Access Compliance Report

Public Rights-of-Way

(Pedestrian Signals)

Intersection ID: N/A	Main Street:	Cross Street: N/A	Location: N/A
ADA ID: 82018BD18A78	Signal Type: One Push Button-Non APS	Overall Compliance: No	Severity Score: BTN 1: N/A BTN 2: N/A No BTN: N/A
Codes/Mitigation Info/Possible Solution		Field Measurements/Component Compliance

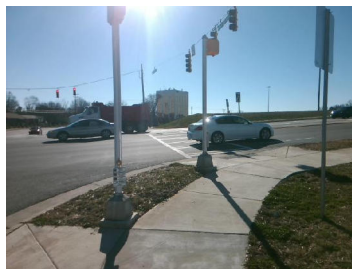
PROW/ADA: TMUTCD 4e.08, R404.2, R406.2

Yes	B 1 Clear Xing Direction?	ClearlyMarked	N/A	B 2 Clear Xing Direction?	N/A
	B 1 Crossing Direction	To NE		B 2 Crossing Direction	N/A
Yes	B 1 DistanceTo XWalk (in)	10.0	N/A	B 2 DistanceTo XWalk (in)	N/A
No	B 1 DistanceTo Curb (in)	81.0	N/A	B 2 DistanceTo Curb (in)	N/A
Yes	B 1 Diameter (in)	2.0	N/A	B 2 Diameter (in)	N/A

Possible Solutions: Replace Signal Push Button With APS Button on New Post. Remove & Relocate Sign.
